**Monitoring Committee, constituted by the
Hon'ble National Green Tribunal,
to oversee certain environmental issues**

OA No. 980 of 2019

**with regard to remedial measures to be
taken to maintain the natural flow of river
Siswan and its tributary passing through
village Bharounjian, Sub Tehsil Majri, Distt.
SAS Nagar.**

27th April, 2021

Fig. -1 Map showing Siswan river, creek in Siswan river bed reaching at Point A, its confluence with Natural drain / Choe (a tributary of Siswan river) passing through village Bharounjian and re-entry of combined stream into Siswan river after point B.

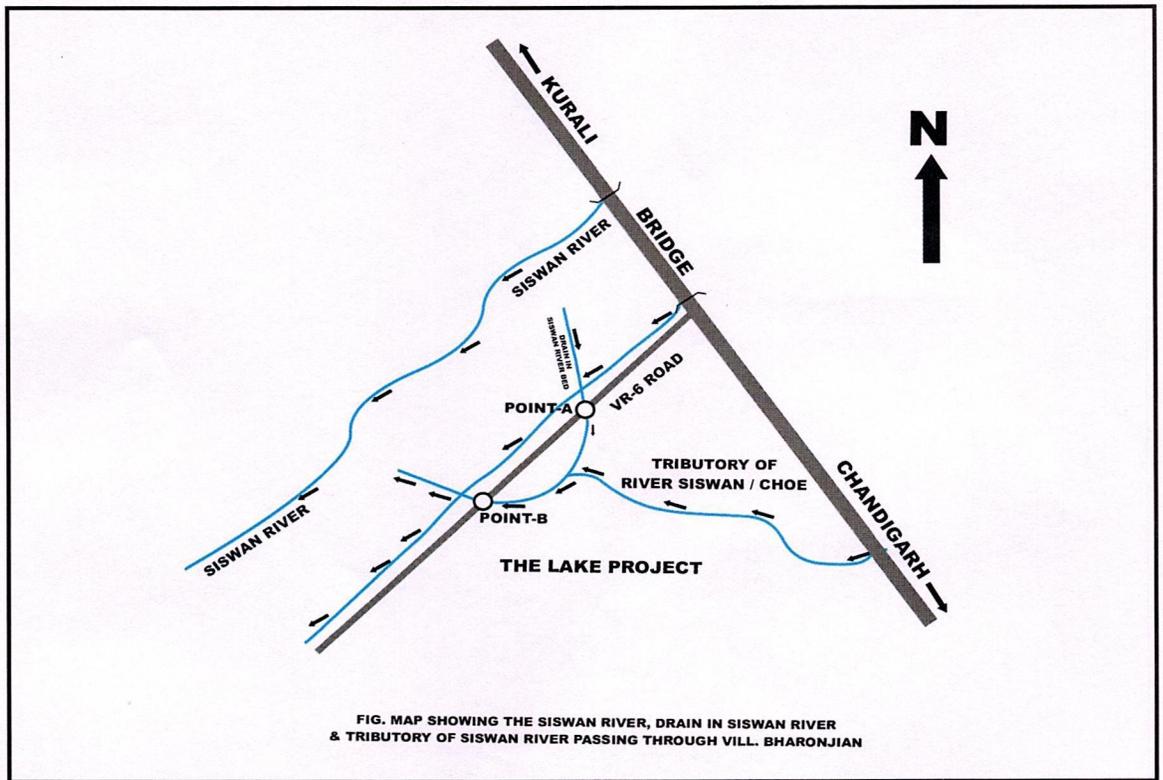
1. The Monitoring Committee was provided with Google earth images of the year 2003, 2006, 2009 and 2015 showing that the creek maintained within the bed of Siswan river was crossing the road (now constructed as VR-6 road) at point A and after its confluence with natural Choe (a tributary of Siswan river) passing through village Bharounjian, it again crosses to road (now VR-6) at point B and thereafter joining to river Siswan. Google earth images of the year 2003, 2006 and 2009 are annexed as per **Annexures 6 to 8**. Photograph showing the creek maintained in Siswan river bed and meeting at point A at VR-6 road is as per **plates-1 and 2**.

Google earth images of the year 2003, 2006, 2009 and 2015 also show the existence of natural Choe / drain (a tributary of river Siswan) passing through village Bharounjain and other adjoining villages and adjoining to The Lake Project (developed by M/s Omaxe Chandigarh Extension Developer Pvt Ltd.) and after its confluence with creek of Siswan River, the combined stream is crossing the road (VR-6 road) at point B and enters into Siswan River through two pipes each of diameter 5 feet but now a culvert to pass 650 cusec of water has been proposed to be constructed for which concreting of bed of natural drain/ choe at upstream of two pipes each of diameter 5' feet is being done. The photographs showing concreting being done to construct culvert and existence of two pipes each of diameter 5' feet at point B are mentioned as per **plates 3 and 4.**

These facts indicate that the creek maintained in Siswan river bed, natural drain / choe (a tributary of Siswan river) passing through village Bharounjain

are in existence before the year 2003 and these creek and natural choe are maintaining their regular course in the area before the year 2003. M/s Omaxe Chandigarh Developer Pvt Ltd while constructing The Lake Project has disturbed the natural course of creek of Siswan river abutting to the project and part of natural drain / choe (a tributary of Siswan river). Therefore, course of natural drainage system of the area needs to be restored to its original course to maintain their natural / ecosystem system. The department of drainage has informed that the department had issued notices to the farmers of the area on 12.6.2014 to 16.6.2014 for raising embankments within the bed of Siswan river and creating a drain and again requesting Naib Tehsildar, Majri, vide letter dated 11.10.2019 to provide the names of the miscreants, who are responsible for reducing the water way of Nadi. The case in regard is pending before the Hon'ble Punjab and Haryana High Court as informed to the Monitoring Committee.

Therefore, the Monitoring Committee recommends that GMADA, SAS Nagar shall construct well designed culvert having adequate span to pass 2000 cusec of water underneath VR-6 road at point-A, for which necessary design and drawing shall be provided by Department of Water Resources within 01 month and culvert may be constructed by GMADA under the supervision of Department of Water Resources within 04 months. The cost of construction of culvert shall be borne by M/s Omaxe Chandigarh Extension Developers Pvt. Ltd. for which M/s Omaxe Chandigarh Extension Developers Pvt. Ltd has already submitted their consent for construction of these culvert bridges vide letter No OCEDPL/DIR 2019-1, dated 22.10.19.

2. After confluence of creek of Siswan river and natural drain (a tributary of Siswan river), it is crossing VR-6 road at point-B, where the discharge of water shall be 2650 cusec, as mentioned by Department of Water Resources. Therefore, a culvert at point B having adequate span length, to pass 2650 cusec a water, for which the necessary design and drawing shall be provided by the Department of Water Resources within 01 month, shall be constructed by GMADA within 04 months under the supervision of Department of Water Resources. The cost of construction of culvert may be borne by M/s Omaxe Chandigarh Extension Developers Pvt. Ltd for which M/s Omaxe Chandigarh Extension Developers Pvt. Ltd has already submitted their consent for construction of these culvert bridges vide letter No OCEDPL/DIR 2019-1, dated 22.10.19.
